## 247 (GLA/GLB) with 235 & 501 - Rearview Camera Noise Optimization

Topic number	LI54.71-P-080349
Version	2
Function group	54.71 - Camera and radar-assisted assistance systems
Date	3/27/26
Validity	247 (GLA & GLB) with all of the following:  - Model Year 2024 and later (Option code 804, 805, 806, etc...)  - Option code 459 or 485 (Steel spring variants)  - Option code 235 AND 501 (PARKTRONIC with Active Parking Assist)
Reason for change	Updating language

View PRIOR to SCN Coding:

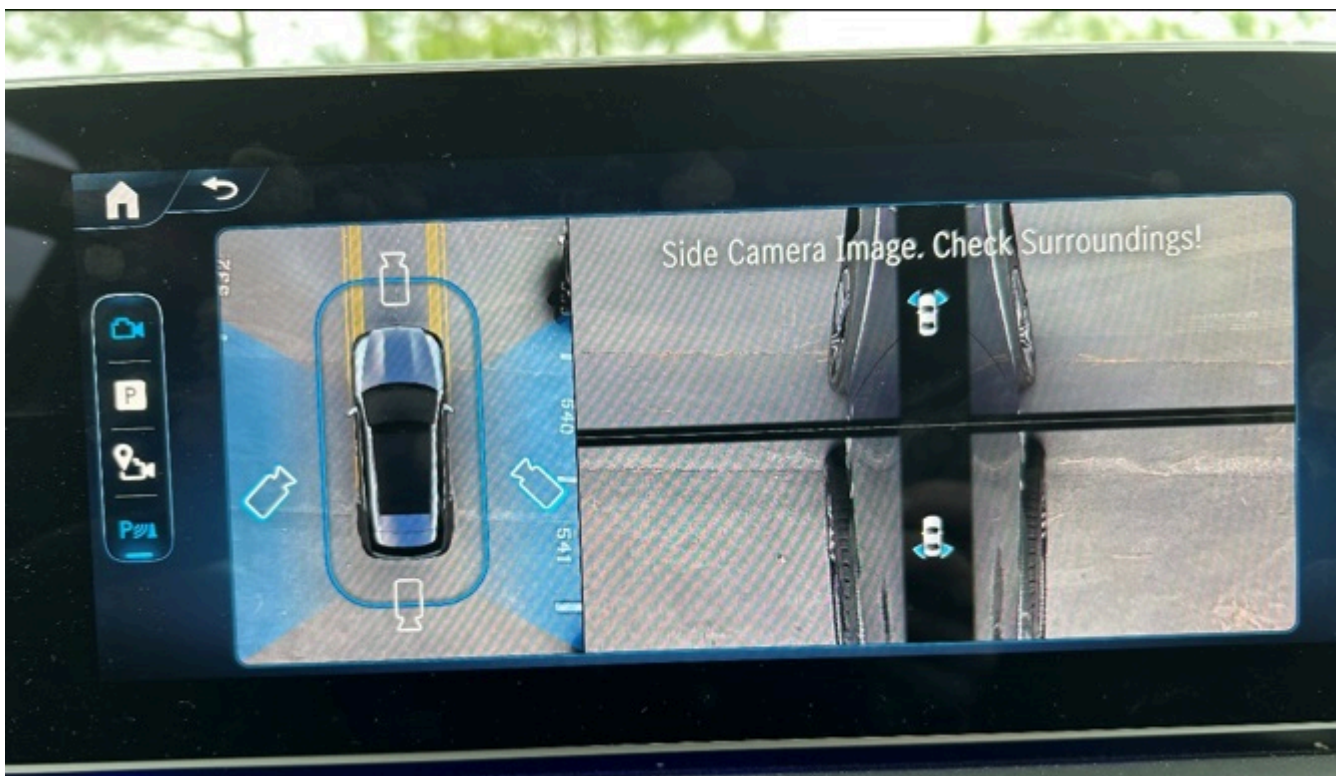
IMPORTANT: After both control units have been SCN coded, the "Movable 3D View" feature in the head unit will no longer be available. With this change there will be two distinct differences:

- 1) The "3D" icon when in the top down vehicle view, will no longer be present on the head unit.
- 2) The digital rendering of the vehicle with the ability to spatially move around the vehicle is no longer possible. This view is replaced with 2D static images of the left and right sides.
